## **PINOLE PLANNING COMMISSION MEETING AGENDA**

**August 10, 2026**

PINOLE SHORES PHASE 2

**Figure 1: Project Location**

A2.1

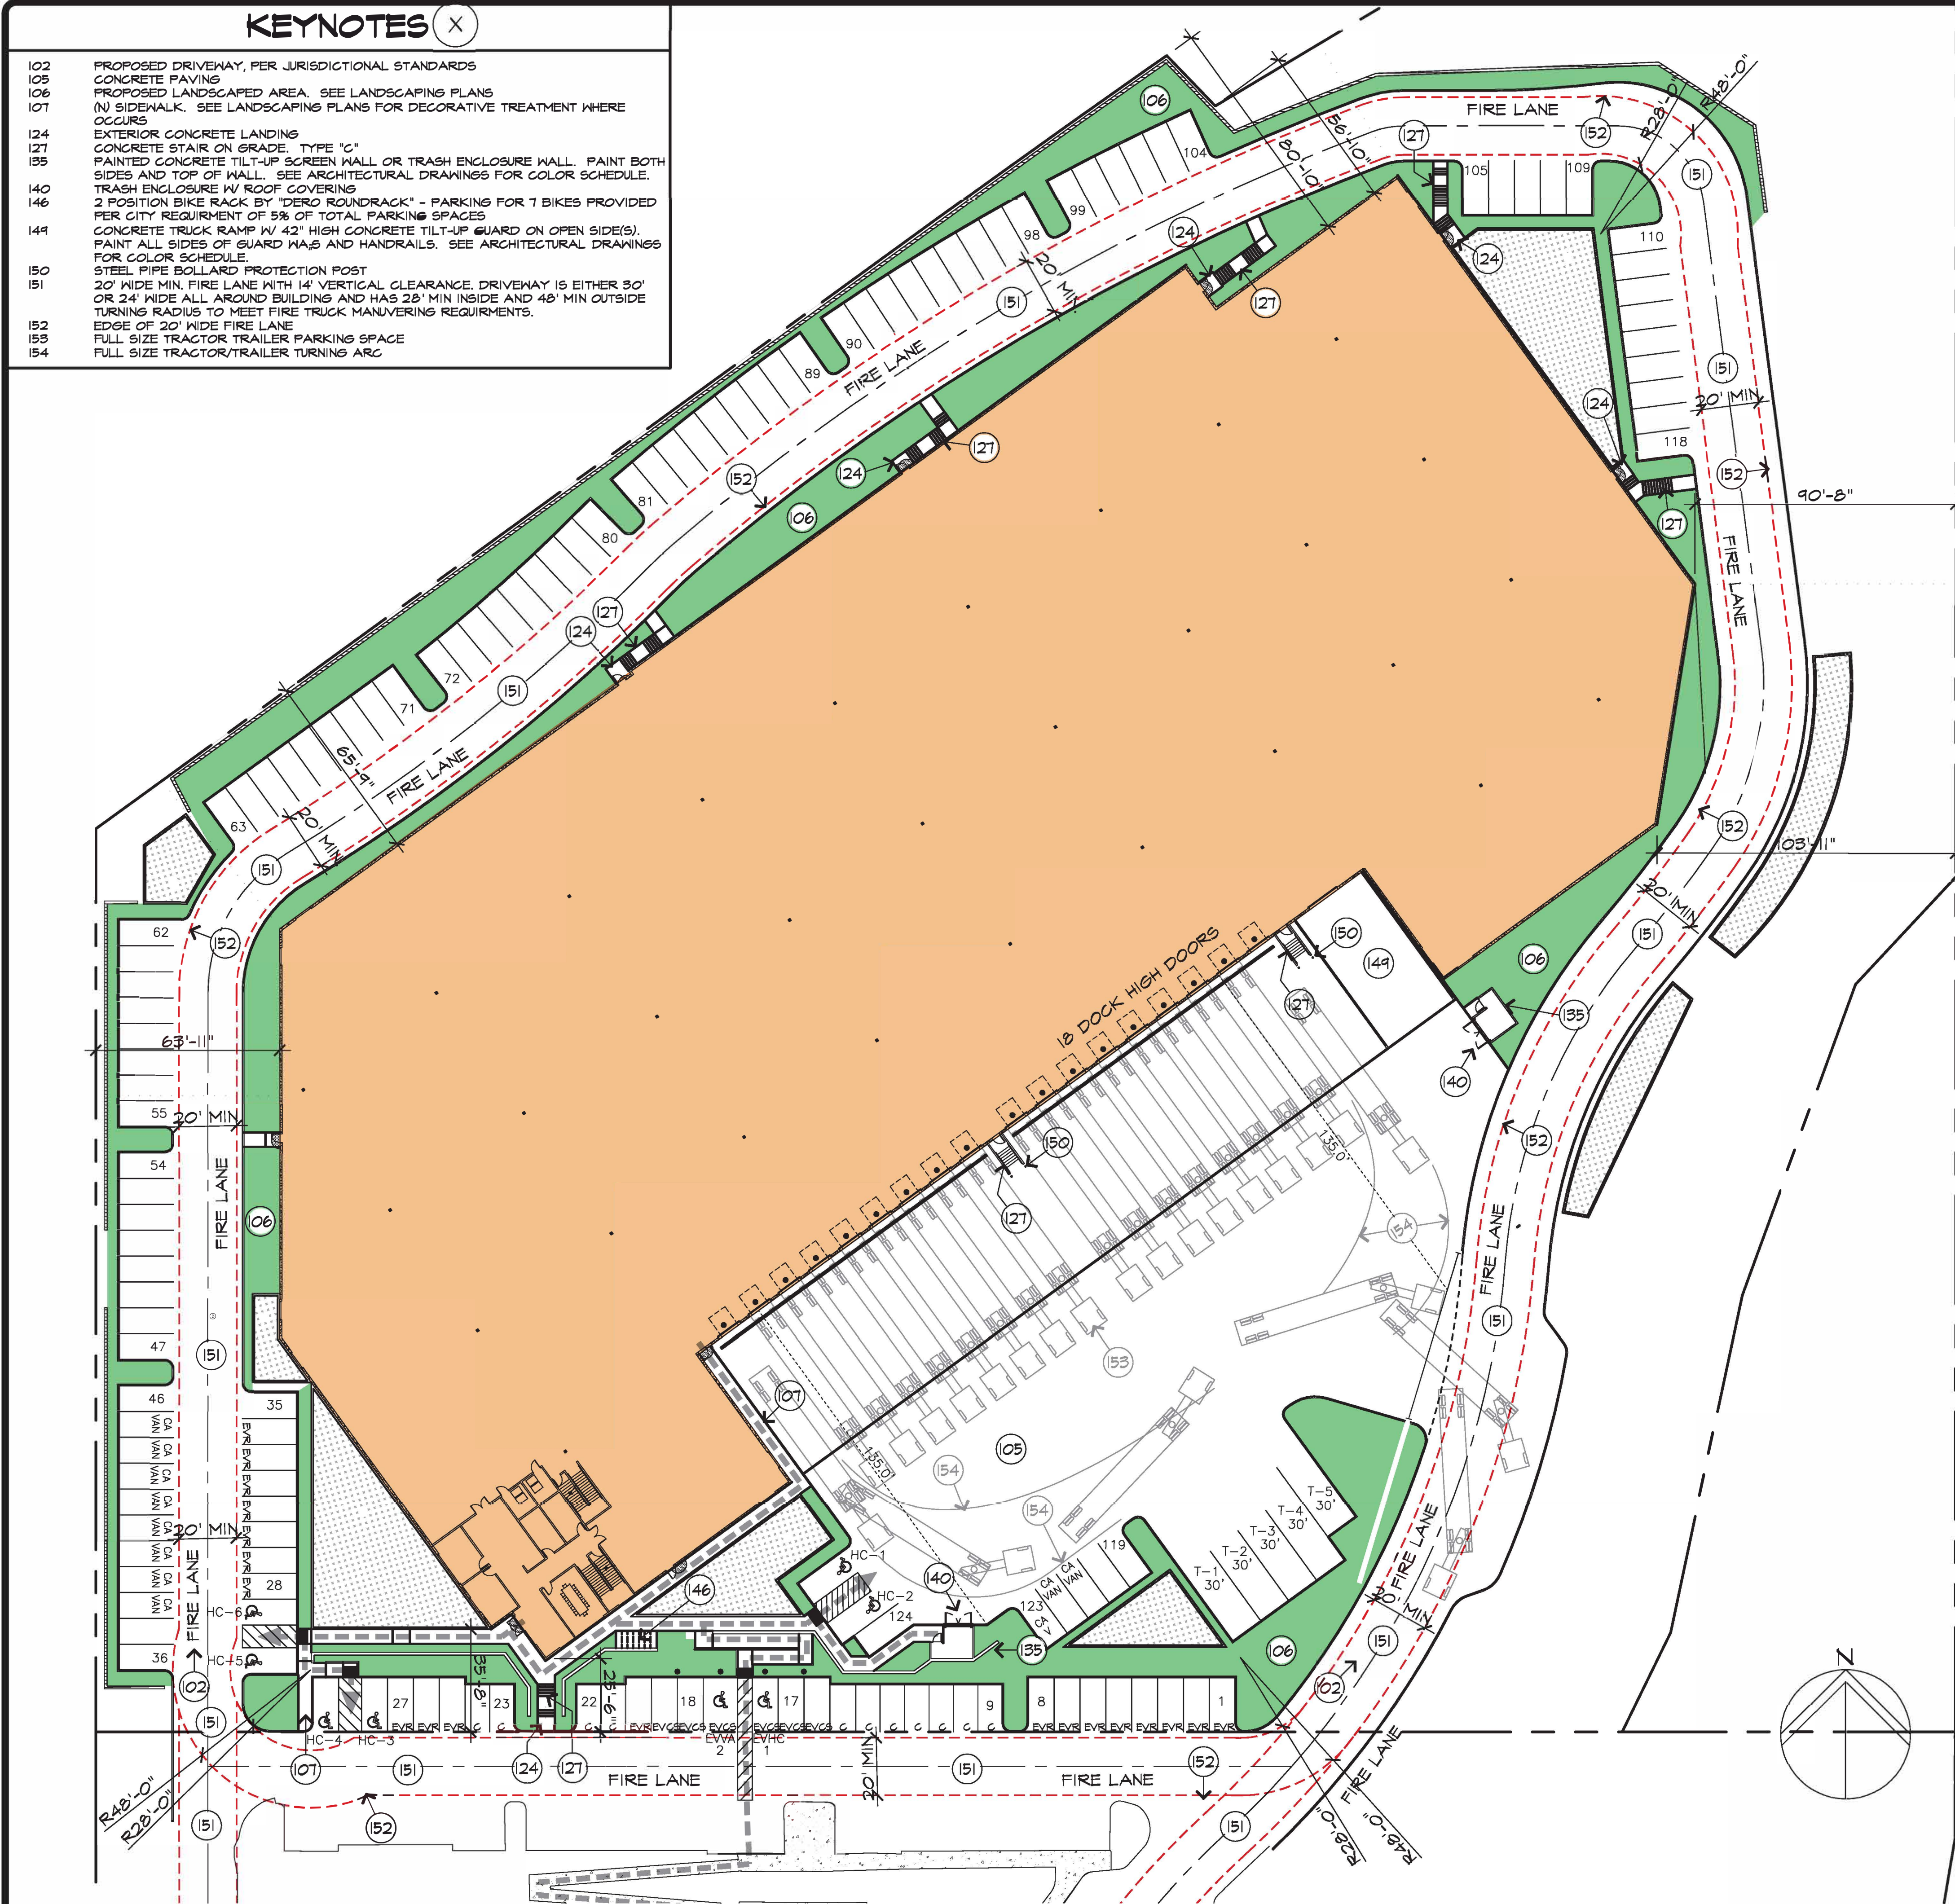
CD-1: Page A2.1- should show the following:

*EV ready and EVCS spaces added to parking count on sheet A1.1.*

*Revised parking counts, requirements, and provided spaces in table on sheet A1.1.*

*Revised parking legend and parking space designations shown on the site plan sheet A2.1*

*Added area to site plan near main entrance and office area that shows parking area for 7 bicycle racks to comply with city requirements. Keynote 146 calls out the area on the site plan sheet A2.1*

*Added a path of travel leaving our site and continuing onto neighboring property on sheet A2.1. Reconfigured parking onsite to better accommodate the existing crosswalk where the existing path of travel terminates on neighboring property.*

*Added keynote 151 to sheets A2.1 and A2.1A to better describe the fire lane being provided onsite. Removed overall roadway width dimensions for clarity and added dimension calling out 20 min wide fire lane instead. Added red dashed lines to site plans on A2.1 and A2.1A to indicated were added to indicate edges of min. width of fire lane occur, Actual paved area always exceeds this minimum lane size. Also added min. turning radius dimensions to fire lane around the site. Turning radius of 28' inside 48' outside meets the requirements for the largest apparatus required by CCC fire.*

drawn  
RH  
checked  
RH  
date  
**03/18/2024**  
scale  
**AS SHOWN**  
job no.  
**2304**  
sheet  
**A3.1**

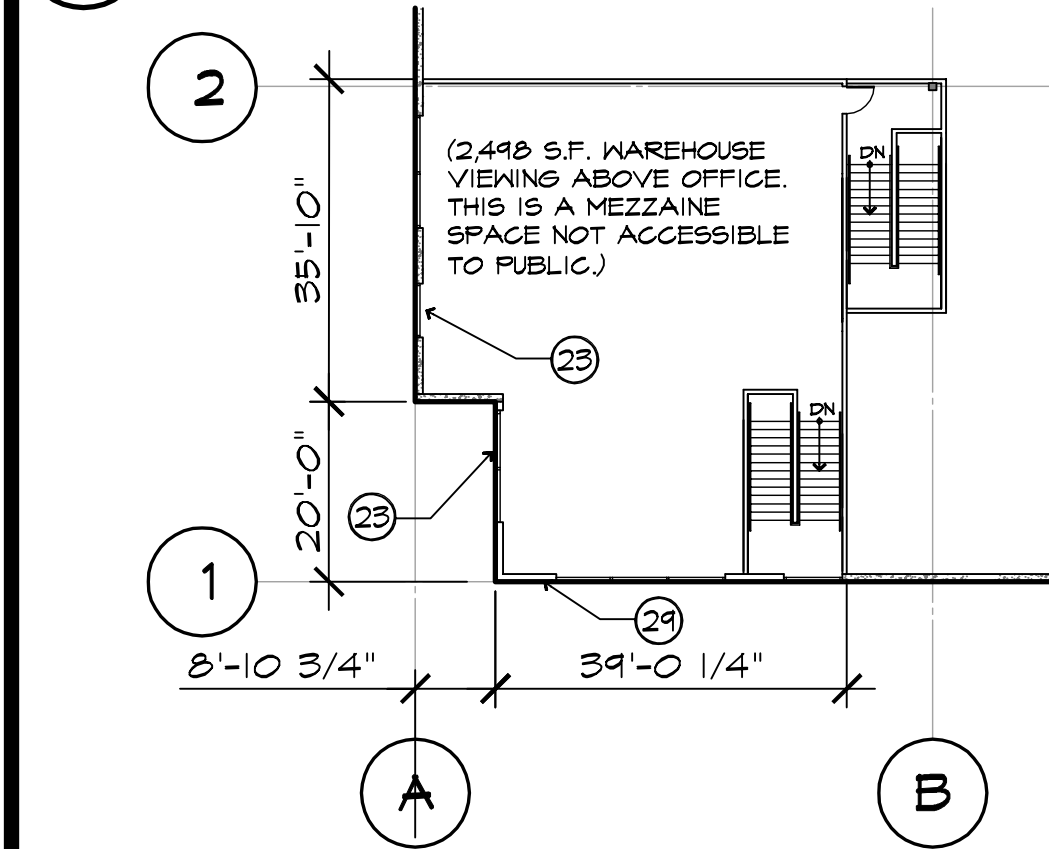
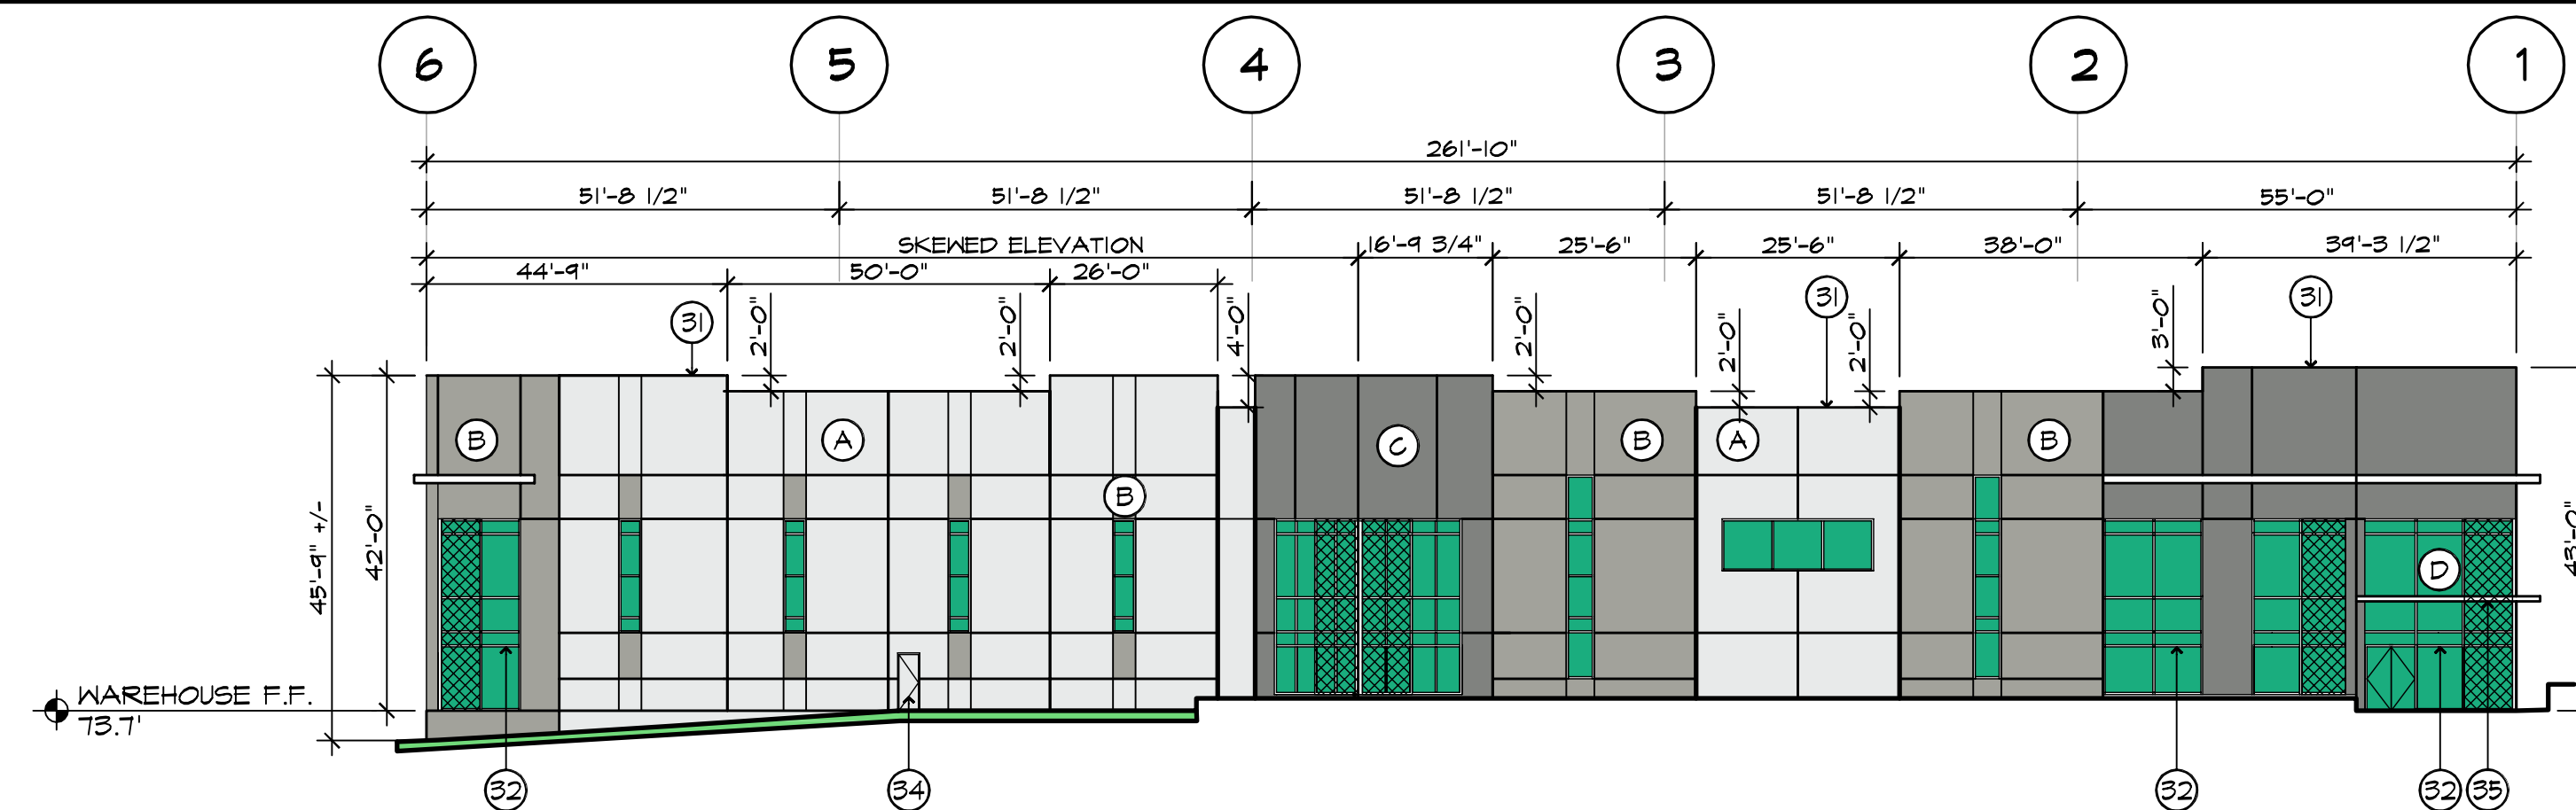
CD-3: Page A3.1- Should show the following:

*Added labels to warehousing viewing area on sheet A3.1 and clarified that the space is not accessible to the public and is therefore not required to be wheelchair accessible. This space is not included as part of the office in the project calculations.*

*Key note legend is on sheet A3.1 towards the bottom of the sheet.*
